Proposed Mosque and Community Facilities  
Croudace Road, Elmore Vale  
Peer Review 2 - Acoustics

Report Number 630.10171-R2

20 July 2011

Figure 1 – Receiver Locations

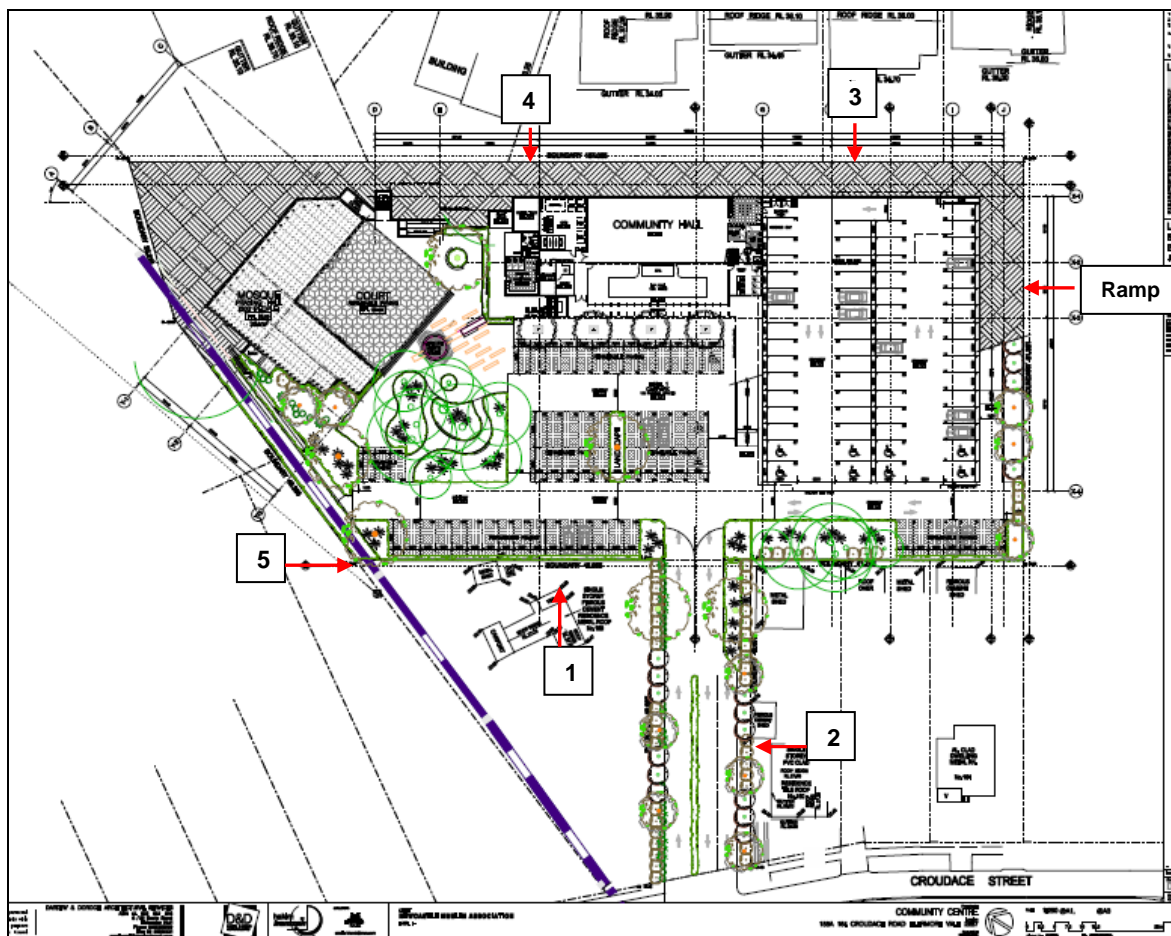
The typical operating scenario utilised for the purpose of assessing noise levels is considered conservative and representative of an acoustically worst-case situation however, it is noted that noise from the ramp is not included in Tables 5 and 6. (Also refer to **Section 3.6** with regard to noise from the ramp.) Furthermore, there is potential for noise from the ramp to have a significant contribution at the residence immediately east of Receiver 3. It is recommended that noise from the ramp be included in the cumulative noise assessment at all receivers including an additional receiver point at the residence immediately east of Receiver 3.

Cumulative noise levels from a typical daytime operating scenario at the Ramp receiver are presented in Table 13 of Spectrum Acoustics letter dated 30 May 2011. This table presents a predicted noise level ( $L_{Aeq}(15\text{minute})$ ) of 41 dBA from Car Park (parks 16-21). It is not apparent where the noise level has been predicted; what distance from the boundary, on ground level or at the balcony? Table 3 of Spectrum Acoustics report dated 21 March 2011 presents a predicted  $L_{Aeq}(15\text{minute})$  noise level of 47 dBA at the rear balcony of this receiver from the Car Park only (parks 16-21).

It is recommended that further information be supplied to clarify the location of the assessment point and the predicted cumulative noise level at this location.

- That noise from the ramp be included in the cumulative noise assessment at all receivers including an additional receiver point at the residence immediately east of Receiver 3.

- That further information be supplied to clarify the location of the assessment point and the predicted cumulative noise level at the Ramp receiver. (Refer to **Section 3.3** for further details.)

Figure 2 – Site Cross Section

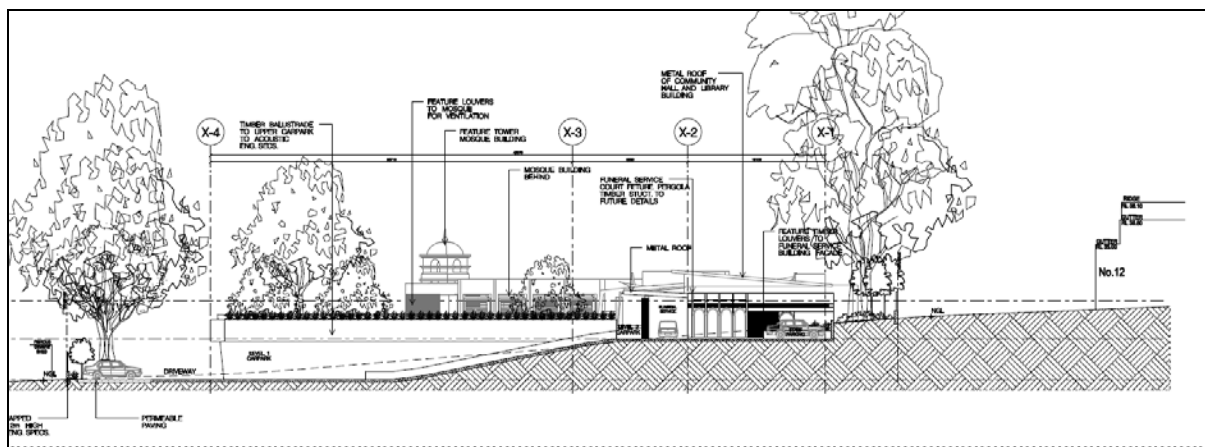
It is recommended that further clarification of this assumption be provided given that the plans of the proposed development show the eastern ramp as an “up ramp” and the western ramp as a “down ramp”. There is potential for the traffic numbers to increase on the ramp if only the “up ramp” is used to access the upper car park.

- That further clarification of the assumption regarding the number of vehicles using the eastern ramp be provided given that the plans of the proposed development show the eastern ramp as an “up ramp” and the western ramp as a “down ramp”.

b) The upper level car park will only be used during the day. It will be closed off at all other times. **Figure 2** shows a cross section through the site which shows that the eastern ramp to the upper level car park rises in cut from existing ground level to the proposed FFL of the car park.

There will be a 2.1m high acoustic barrier along the boundary of the site adjacent to the ramp. Where the ramp rises above natural ground level then there will be a 2.1m high acoustic barrier at the boundary of the nearest residence.
